GLAST Large Area Telescope

LAT MRB for ACD FREE Board

NASA Goddard Space Flight Center
Laboratory for High Energy Astrophysics

Present Circuit

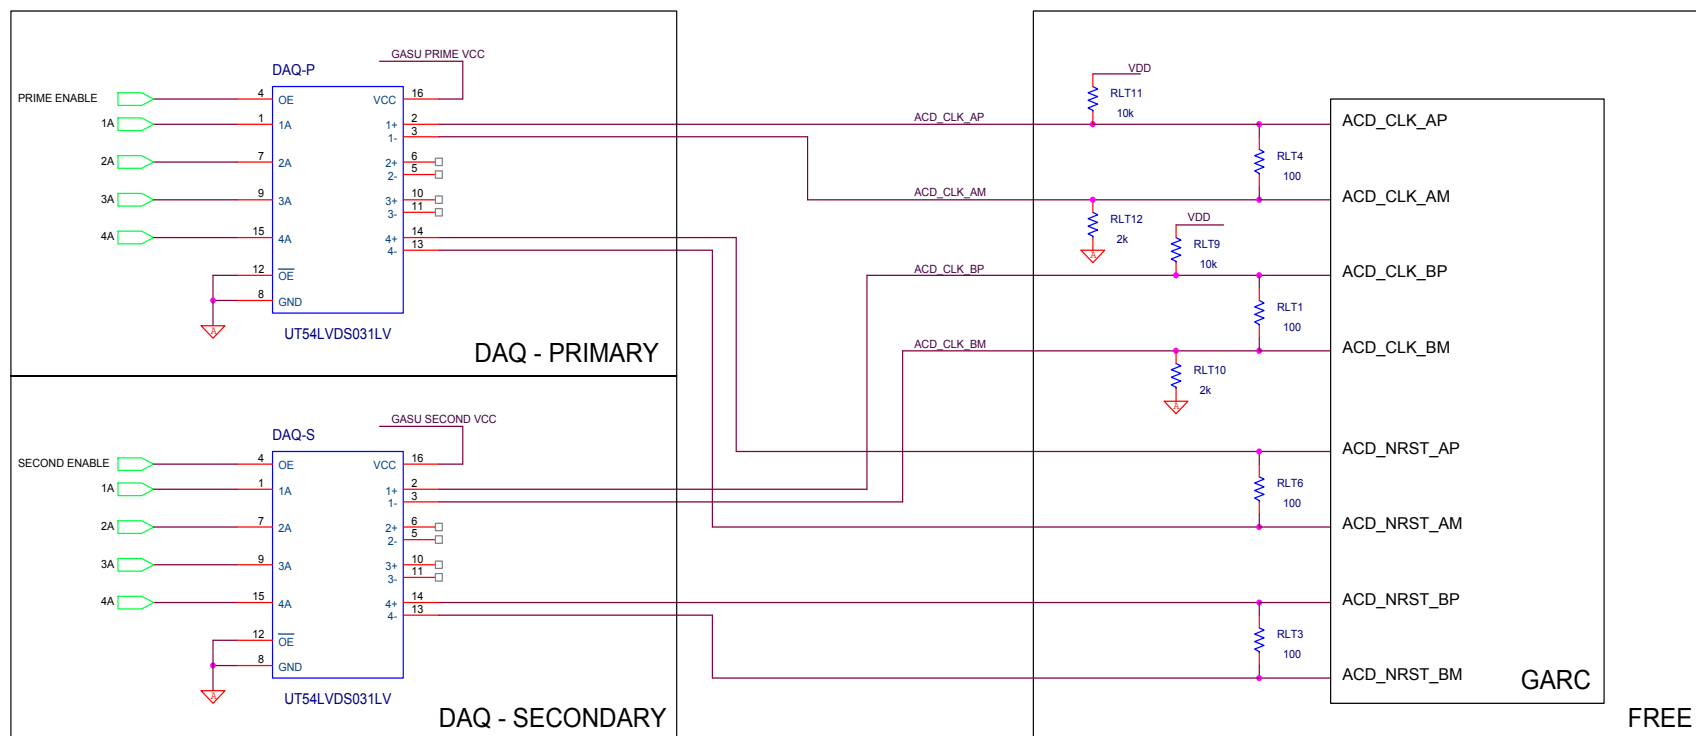
The proposed modification involves cross-strapping the clock and reset inputs to allow a portion of the transmitted signal to be seen by both sets of receivers. The circuit as it presently exists on the FREE card is shown below

Proposed Circuit

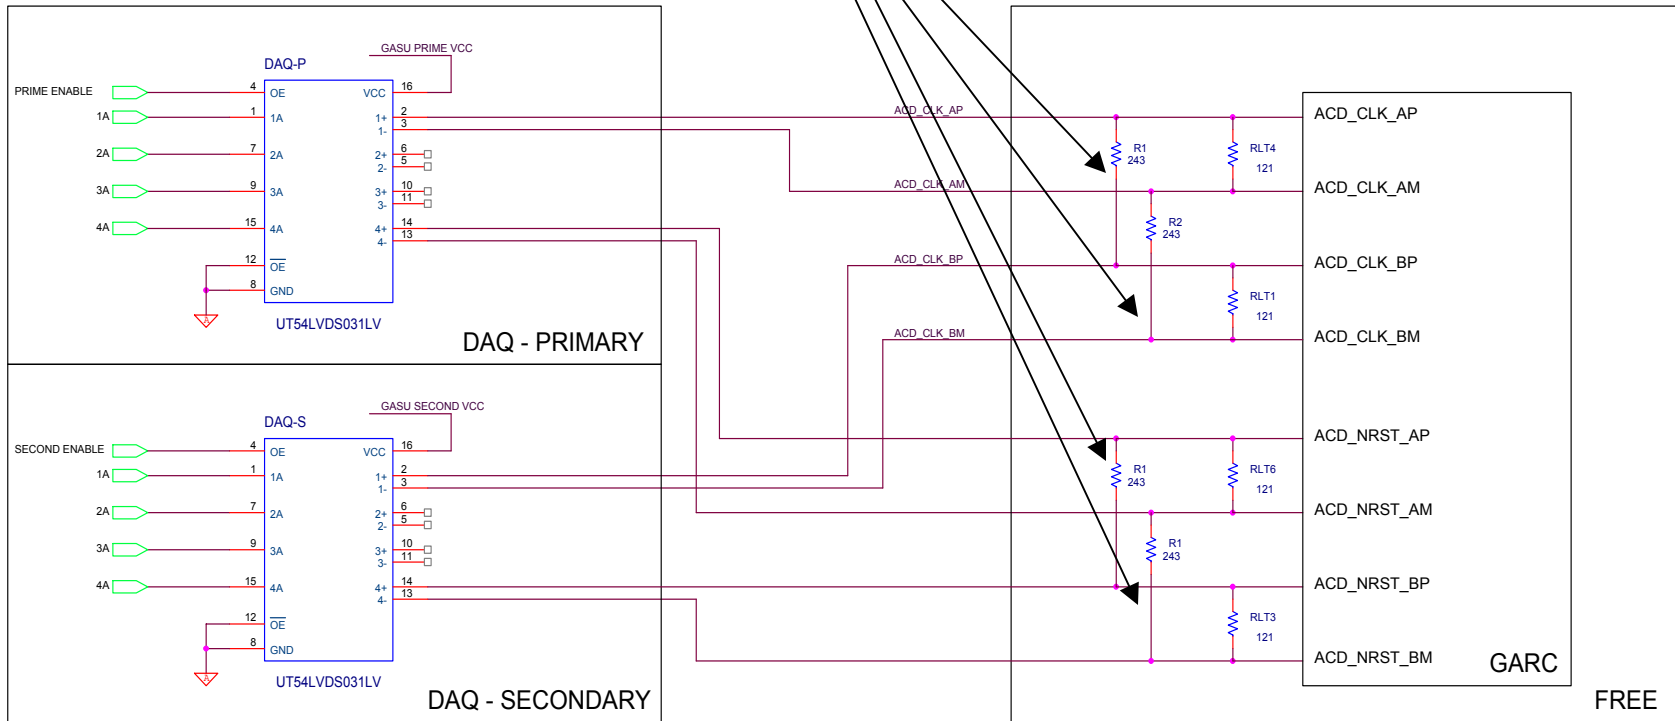
Schematic of Proposed Fix

The 243 ohm resistors show the cross-strapping between the receiver pairs

Impedance Calculation

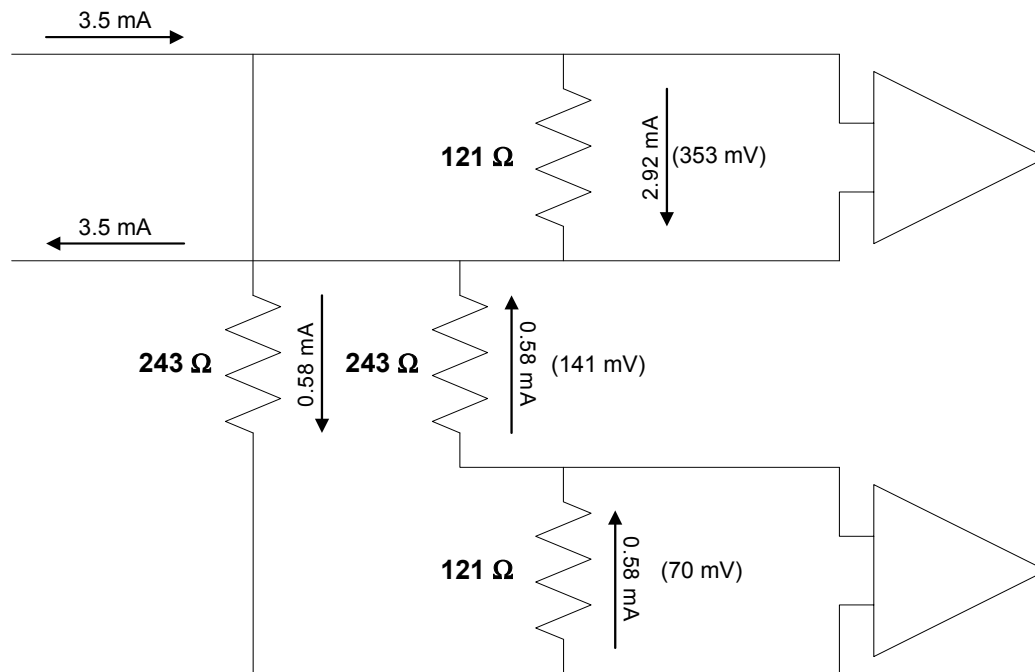
Total termination impedance using the 121 Ω resistors at the receiver inputs and the 243 Ω cross-strapping resistors is:

$$Z = \frac{(121)(243 + 121 + 243)}{121 + 243 + 121 + 243} = 100.9\Omega$$

which is close to the desired 100 Ω termination.

Test Setup at Goddard

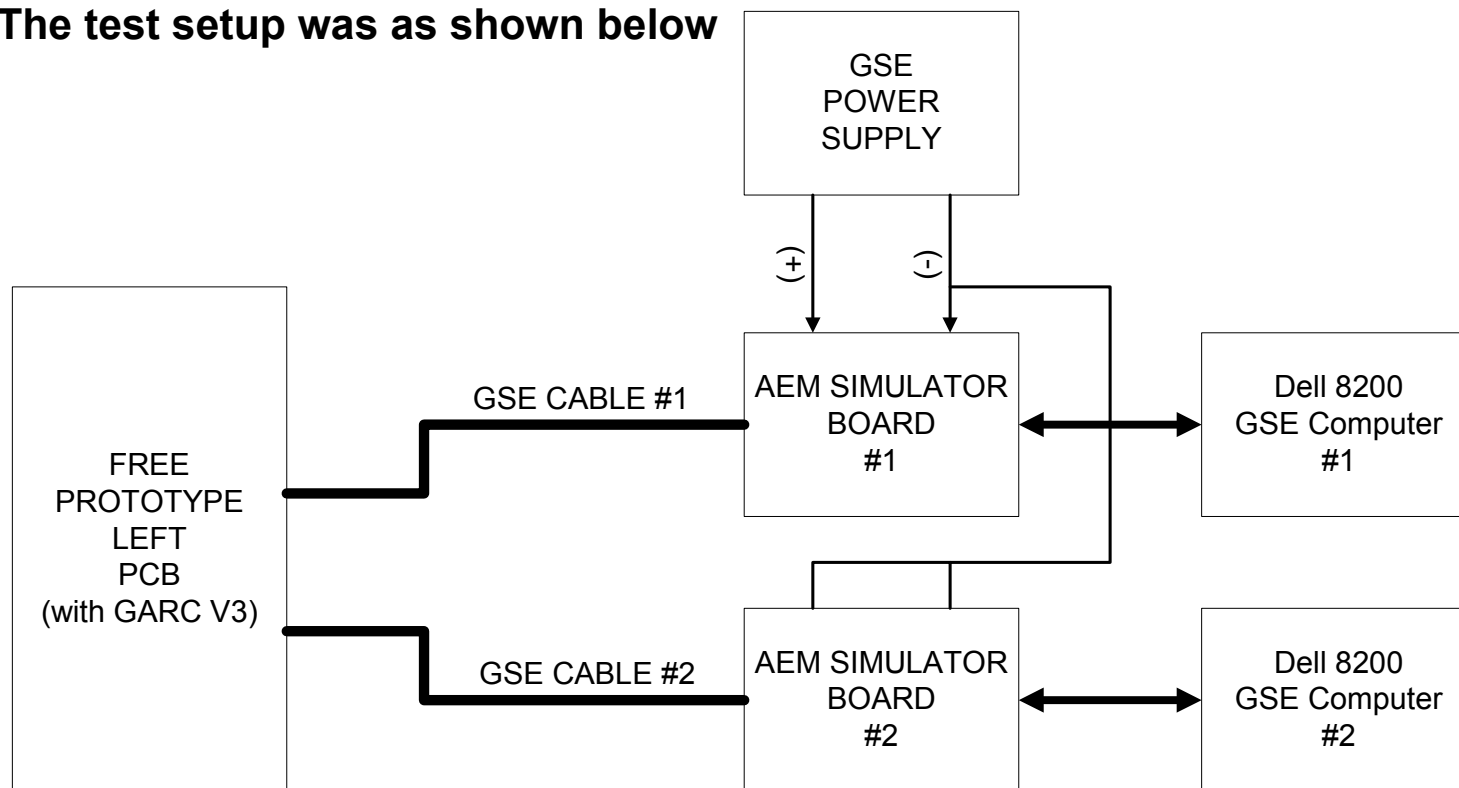
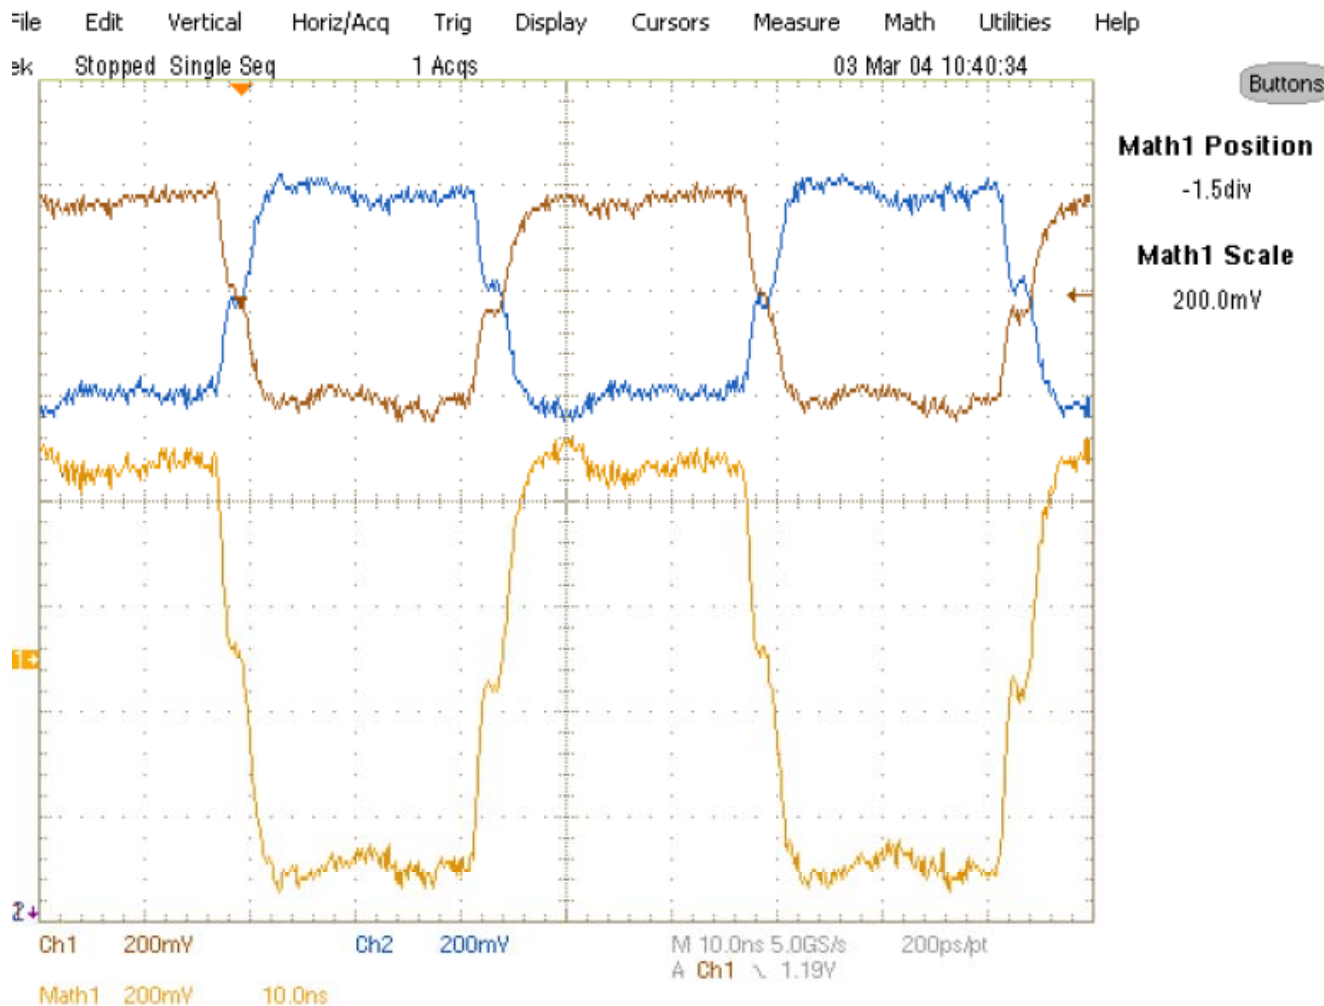
This modification has been tested on the bench with a setup that is similar to the flight configuration (we plan to retest with the GASU when it becomes available).

The test setup was as shown below

In this setup, AEM simulator board #2 was kept powered off with the power leads shorted together and tied to ground. This is to simulate the redundant (unpowered) DAQ card in the GASU.

Test Results - Unpowered Receiver at 1MHz Clock

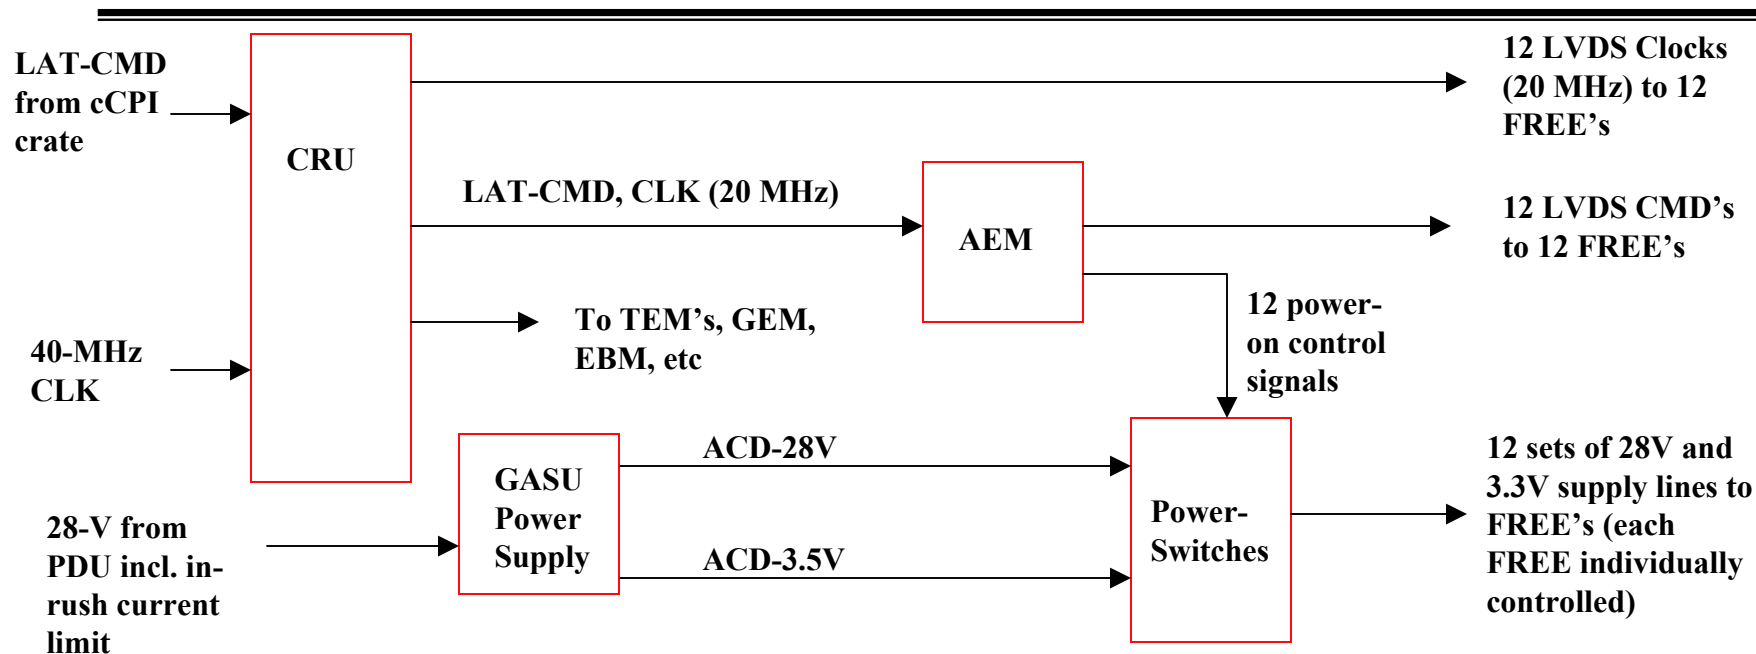
Probes at RLT1
unpowered receiver

Unpowered receiver, 1 MHz, Differential signal is ~ 150 mV

New Design of DAQ-GASU

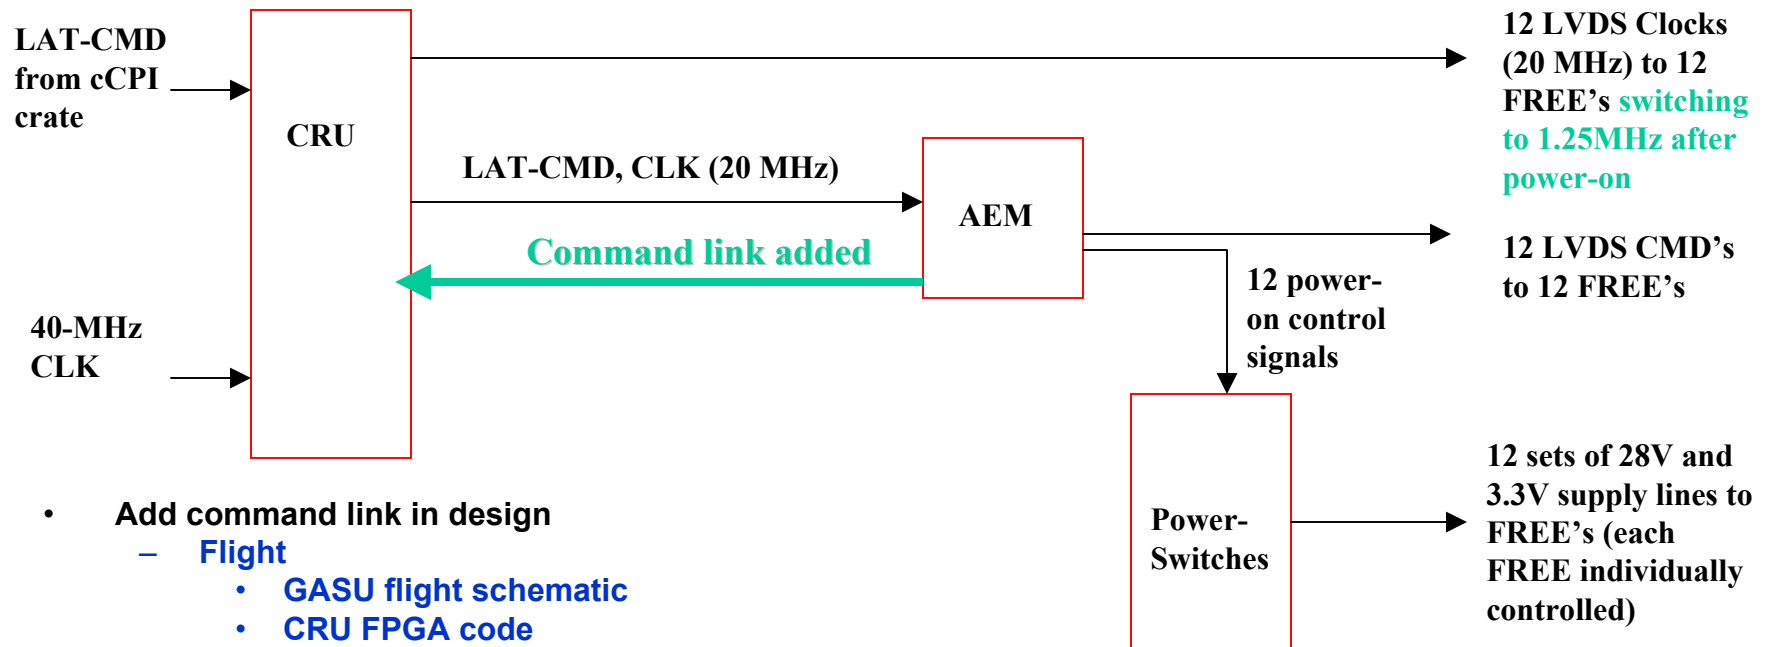
- **Add command link in design**
 - **Flight**
 - GASU flight schematic
 - CRU FPGA code
 - AEM FPGA code
 - **G3 test-stand**
 - Add wires on G3-GASU board
 - Modify CRU and AEM FPGA code
 - Modify software for AEM register control
- **Need to see how to test since 1.25MHz clock is only temporary and effect on FREE can not be "read-back"**
- **Question of**
 - "hard-wire" 1-sec 1.25Mhz duration only at power-up
 - Add register in AEM to select frequency independent of power-up
